Case Number: R18038

CASE COMMENTS:

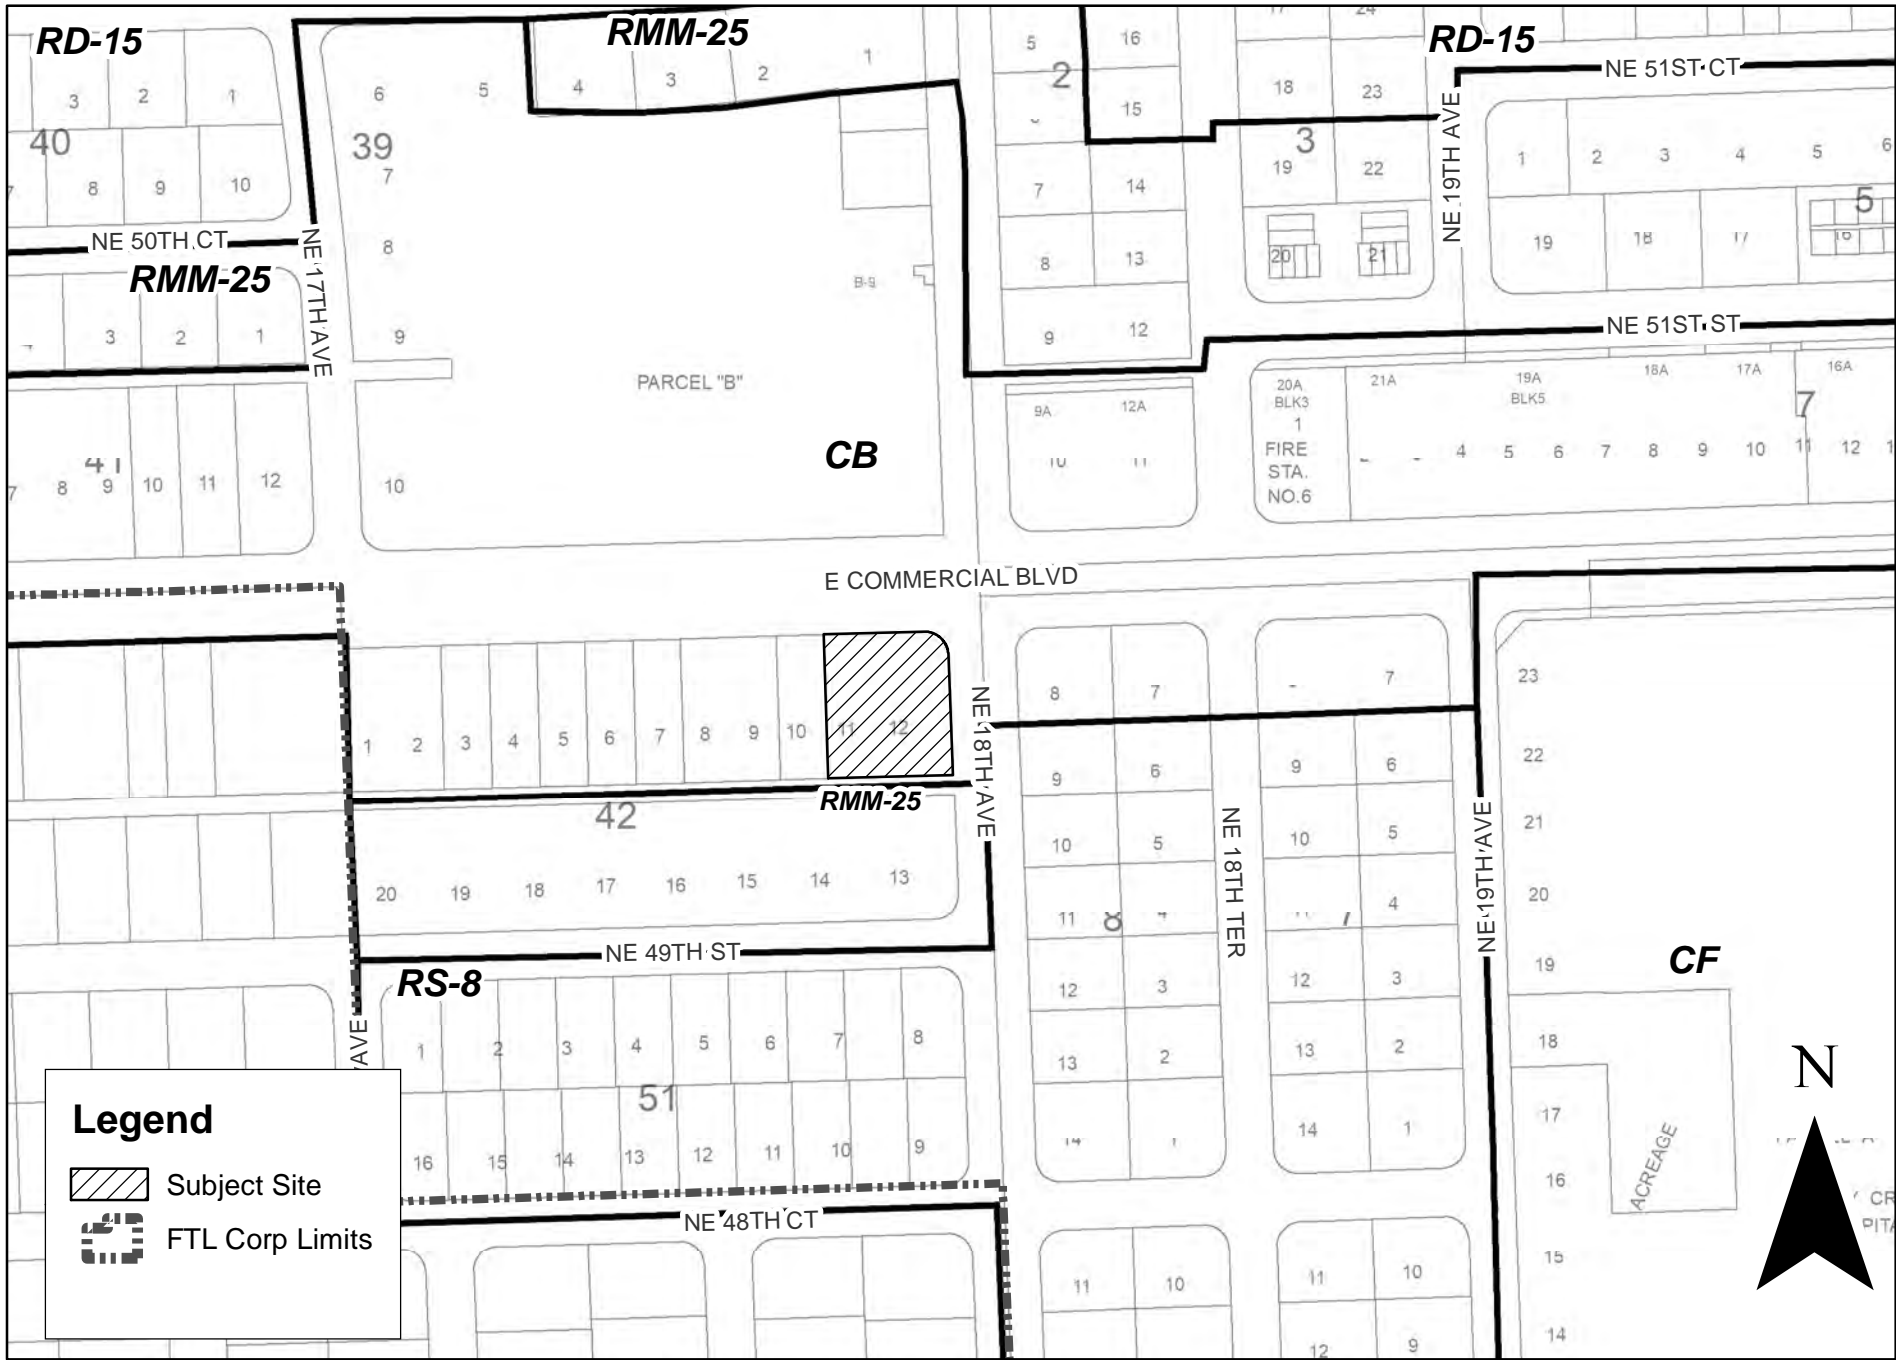
- 10) Move the building closer to the corner of Commercial Boulevard and NE 18th Avenue and re-locate the drive-thru to help activate the street frontage, support pedestrian and multi-modal options and encourage direct access from the sidewalk. Refer to the layout of the Community Bank located at 632 S. Federal Highway (developed by the same owner) as an example. See below site plan:
